FINAL DRAINAGE REPORT

LARGENT SUBDIVISION 6985 MERIDIAN ROAD

January 18, 2018

SF-18-003

SHEET: **EX1**

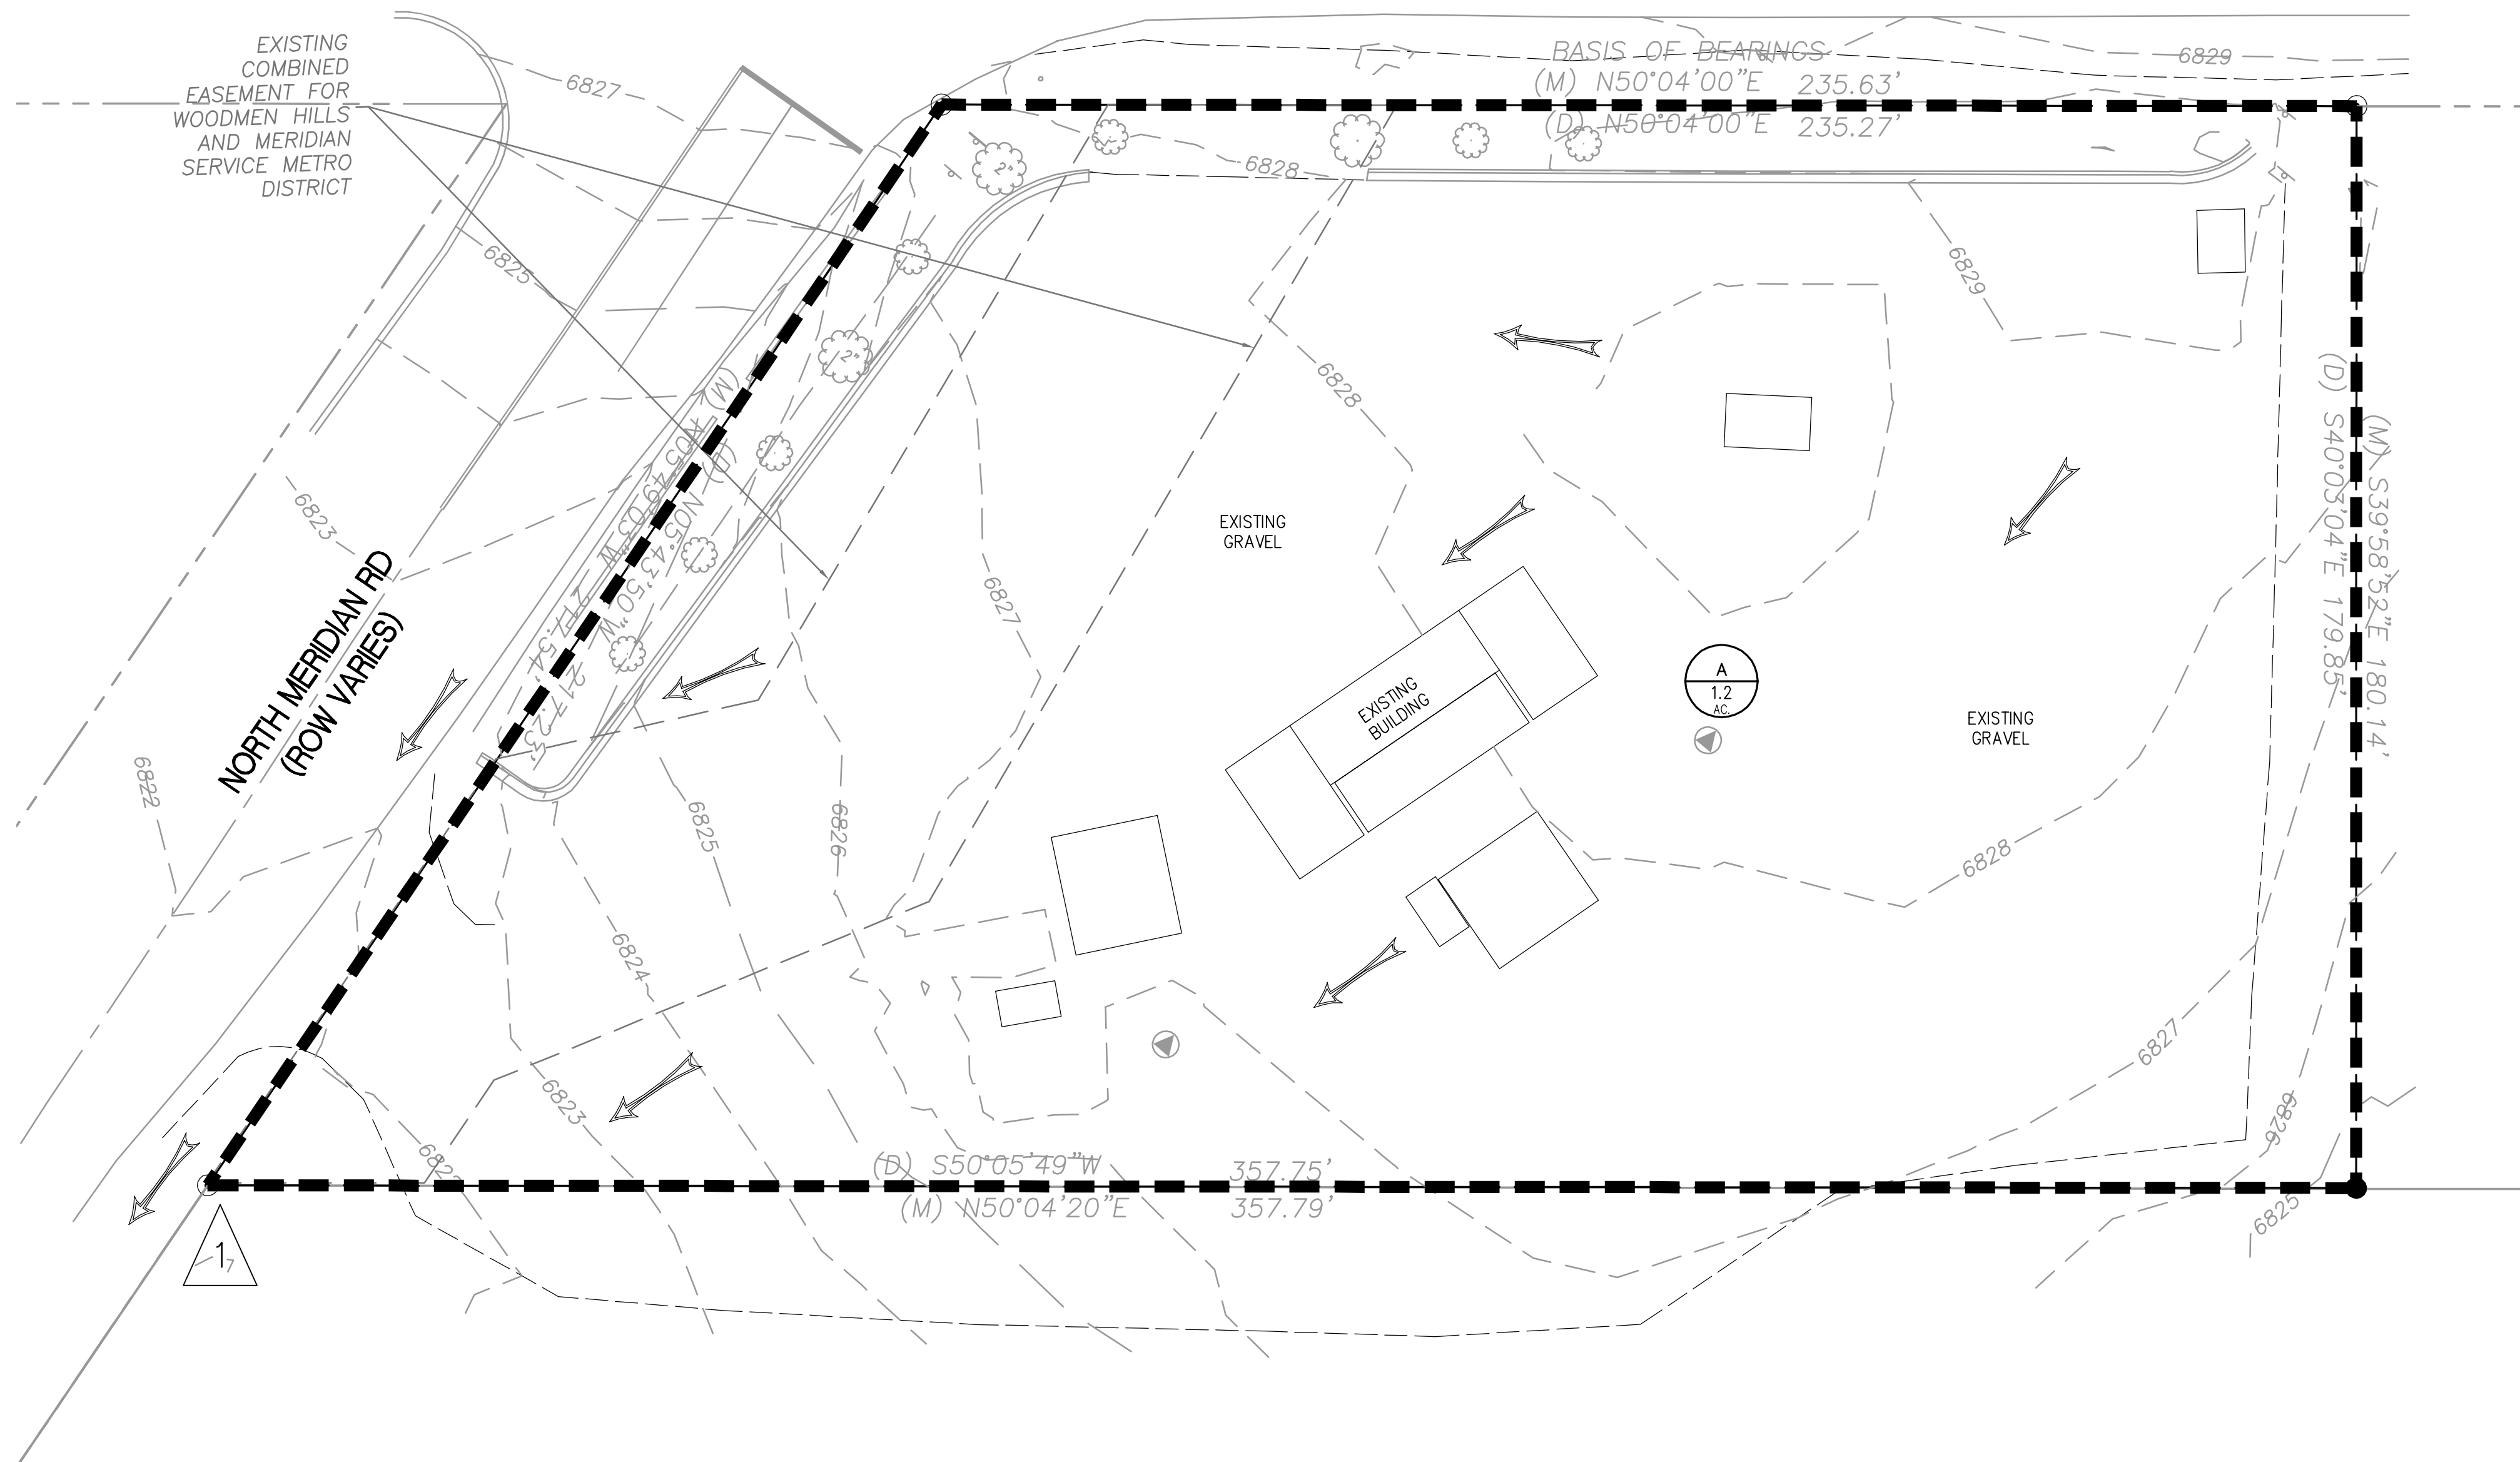
What's being calculated is based on existing condition not historic condition. Change the header to "Existing Condition"

SHEET: **D1**

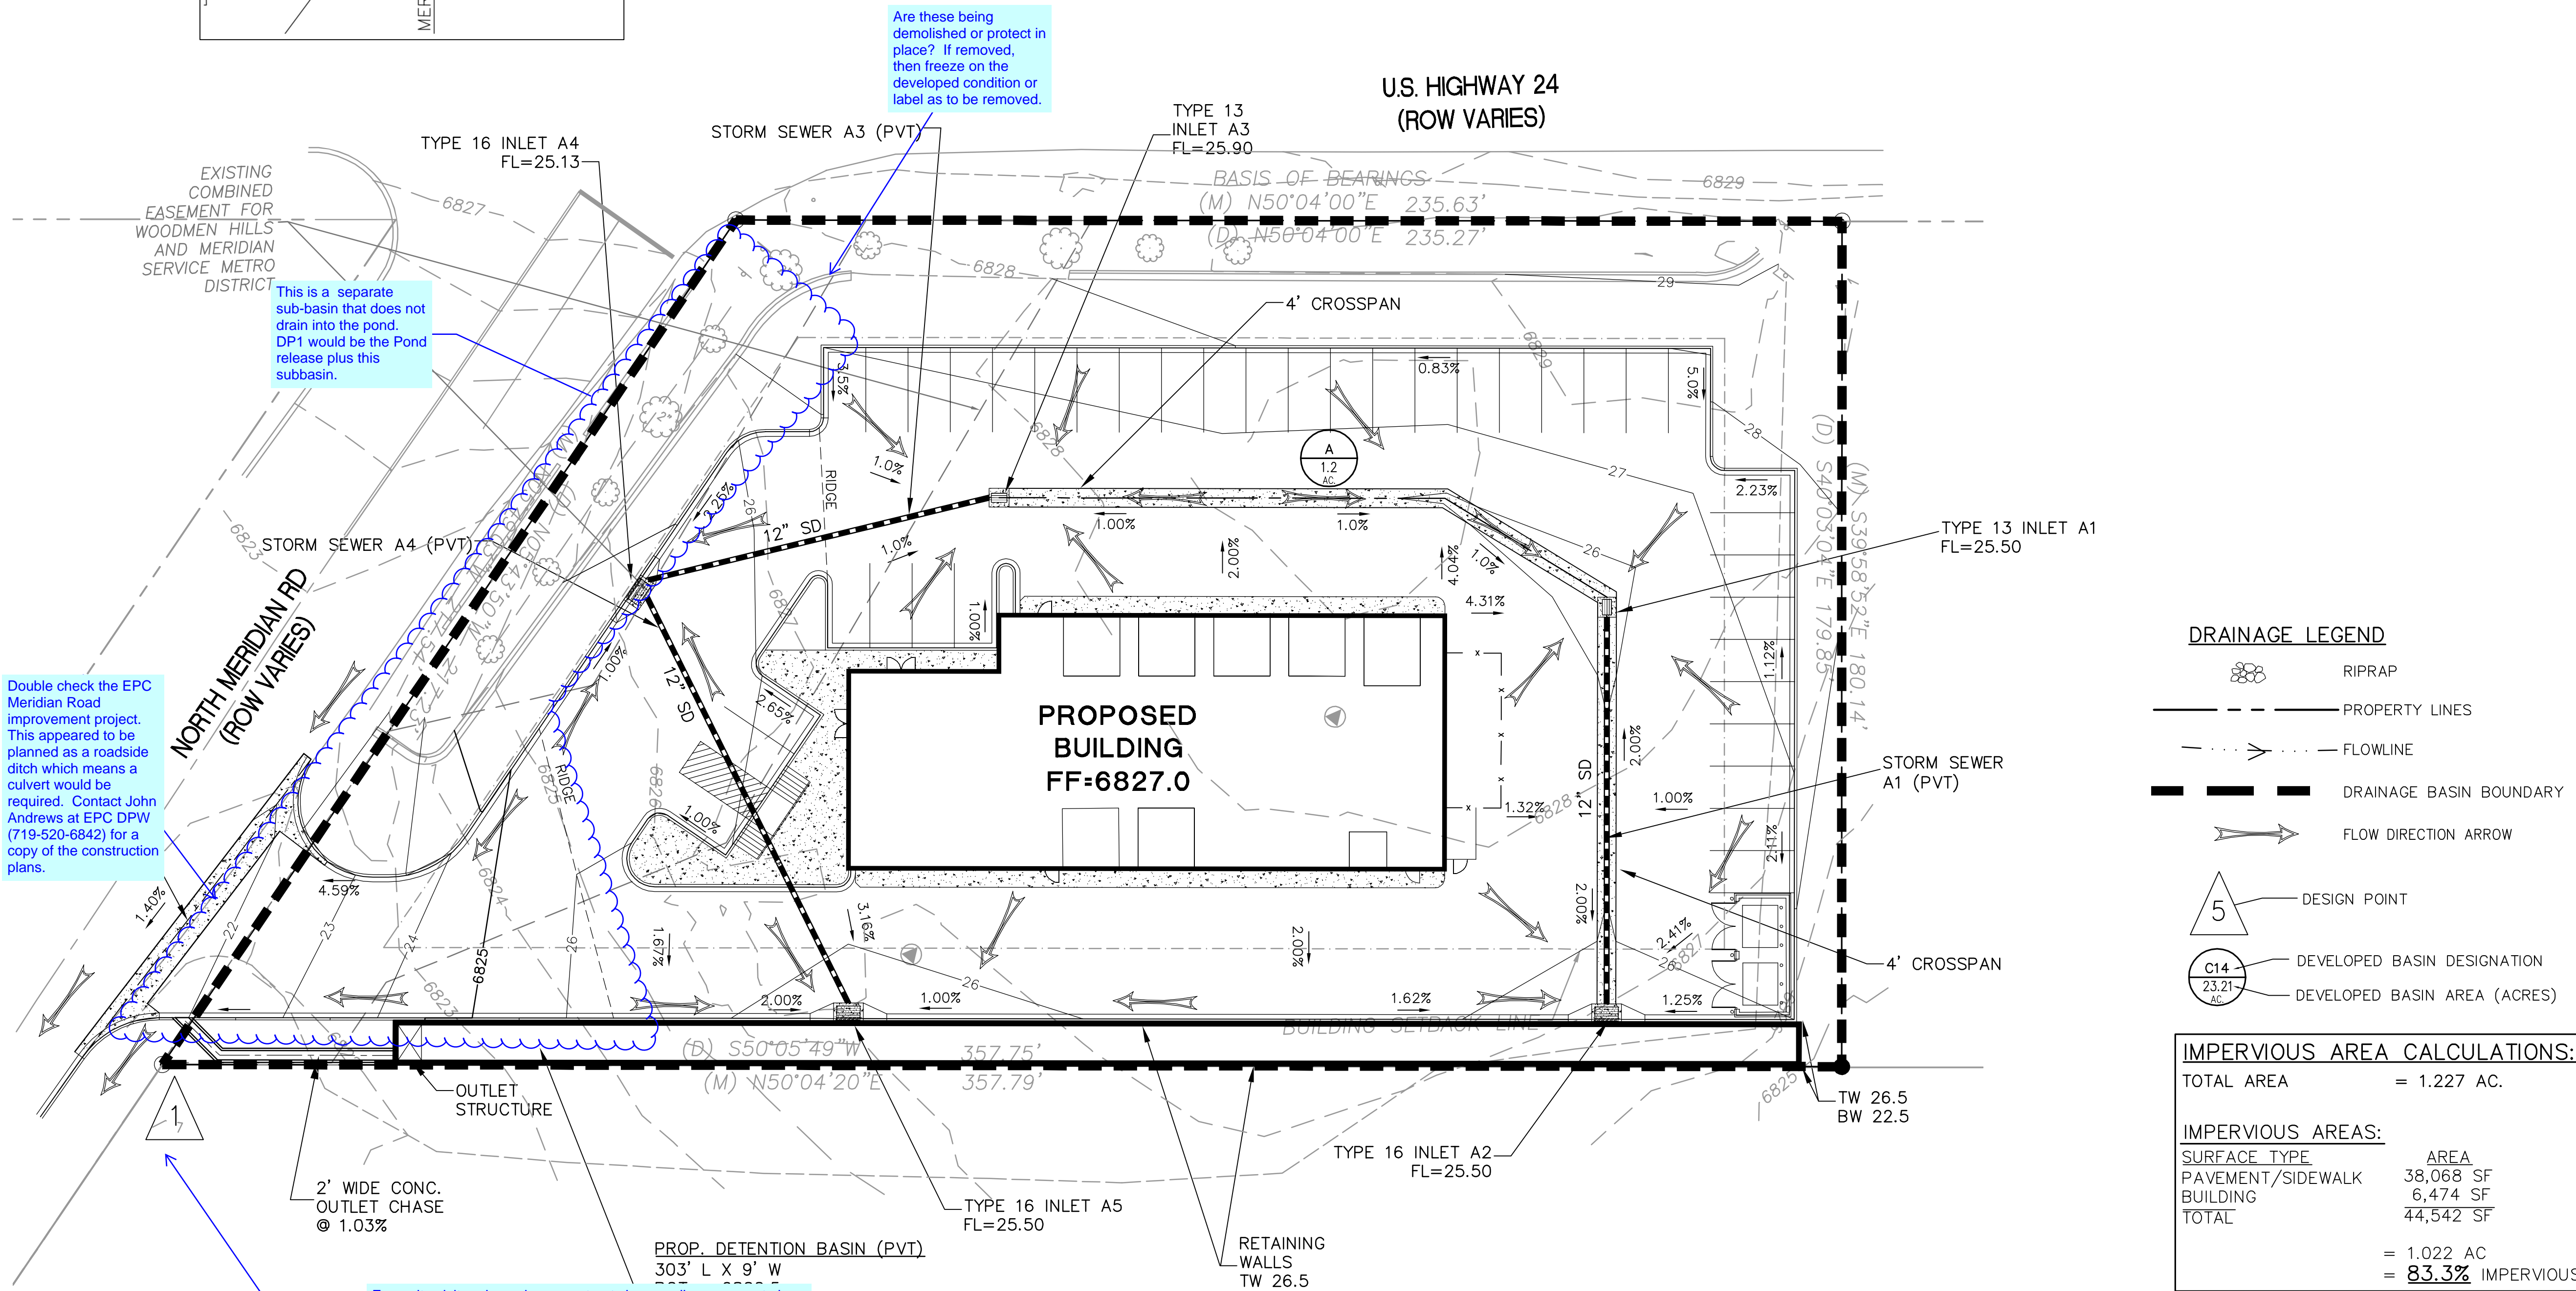
This is a separate sub-basin that does not drain into the pond. DP1 would be the Pond release plus this subbasin.

Are these being demolished or protect in place? If removed, then freeze on the developed condition or label as to be removed.

Double check the EPC Meridian Road improvement project. This appeared to be planned as a roadside ditch which means a culvert would be required. Contact John Andrews at EPC DPIW (719-520-6842) for a copy of the construction plans.

From site visit and google maps street view ponding appears to be occurring on the roadside immediately downstream which indicates design point 1 is not the suitable outfall location (Hydraulically inadequate).
 Extend the the analysis further downstream from DP1 to a suitable outfall and provide recommendations for the required improvements.
 Update the narrative accordingly. Offsite improvements may be required.
 See ECM Chapter 3 Section 3.2.4 for Suitable Outfall Location definition.

Revise to the pond release rate from the UD-Detention Worksheet.
